City of Portland, Maine - Building or Use Permit Application

Location of Construction: 98 PLEASANT ST	Owner Name: COSTIN MICHAEL N & MARY E	Owner Address: 98 PLEASANT ST APT 2	Phone:
Business Name:	Contractor Name: CSI Builders	Contractor Address: 41B Woodville Falmouth	Phone: 2078316966
Lessee/Buyer's Name	Phone:	Permit Type: Alterations - Multi Family	Zone: R-6

Past Use: 4 Unit Apartment building legal use - 4 du. (perm. #02-0635)	Proposed Use: 4 Unit Apartment building - 1 window replacement in apt 3 and enlarge one opening create pass thru in apt 2 to access apt 3 not proposing change of use or removal of kitchen	Permit Fee: \$220.00	Cost of Work: \$20,000.00	CEO District: 1
Proposed Project Description: 1 window replacement in apt 3 and enlarge one opening create pass thru in apt 2 to access apt 3 not proposing change of use or removal of kitchen		FIRE DEPT: <input checked="" type="checkbox"/> Approved <input type="checkbox"/> Denied	INSPECTION: Use Group: R2 Type: SB DOB-2003 Signature: JMB 6/19/08	
		PEDESTRIAN ACTIVITIES DISTRICT (P.A.D.) Action: <input type="checkbox"/> Approved <input type="checkbox"/> Approved w/Conditions <input type="checkbox"/> Denied Signature: ___

~~PROPOSED ROOF WINDOW~~

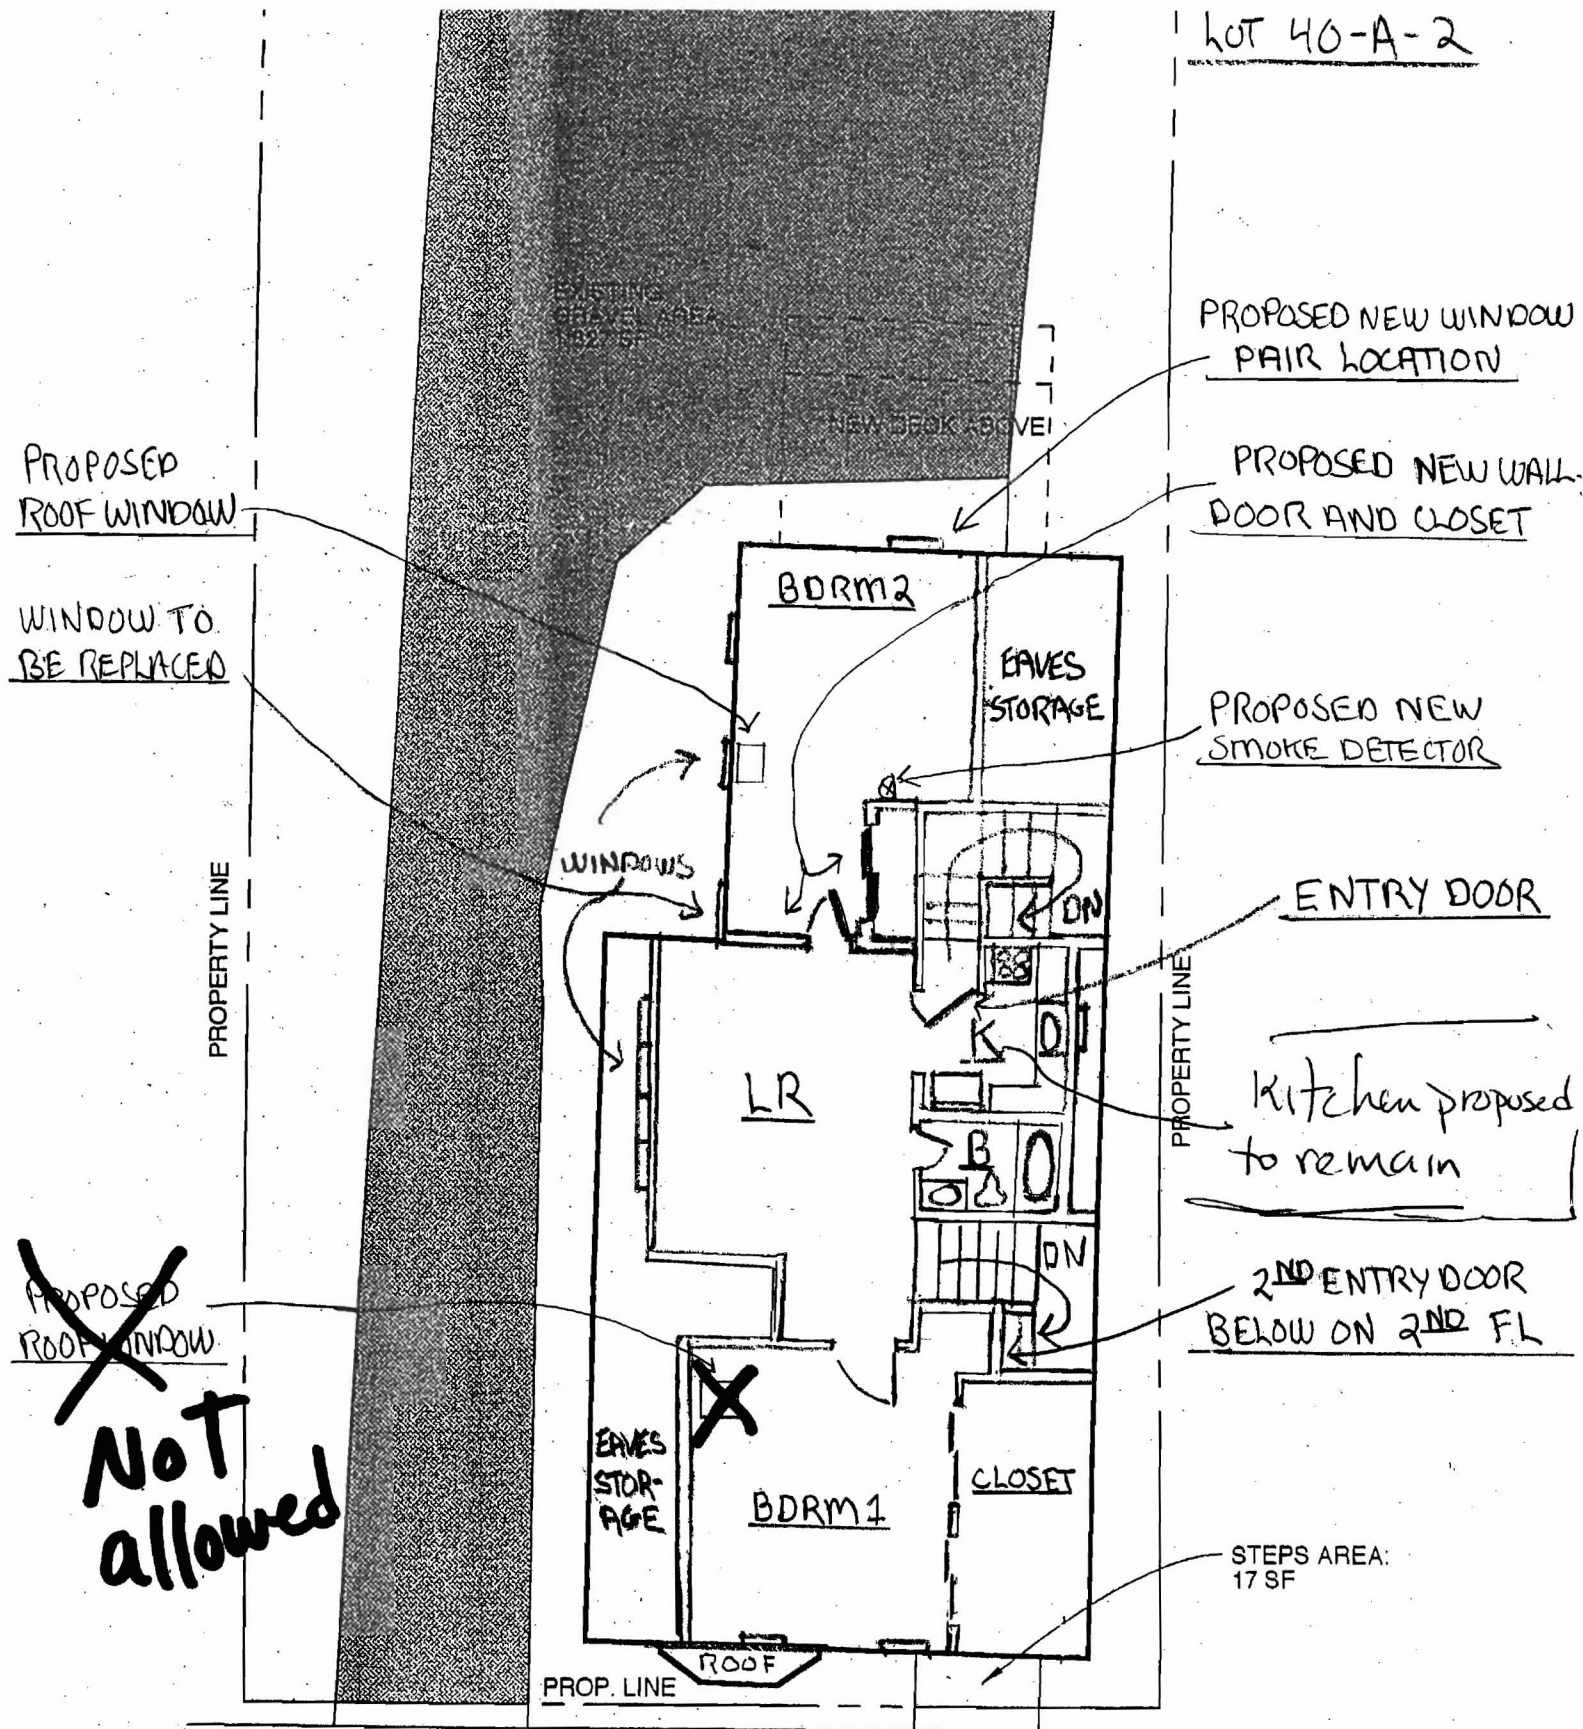
Not allowed

- The skylight proposed for the east-facing roof plane of the main house is to be relocated to the west-facing roof plane. (The position on the roof plane would remain the same.)
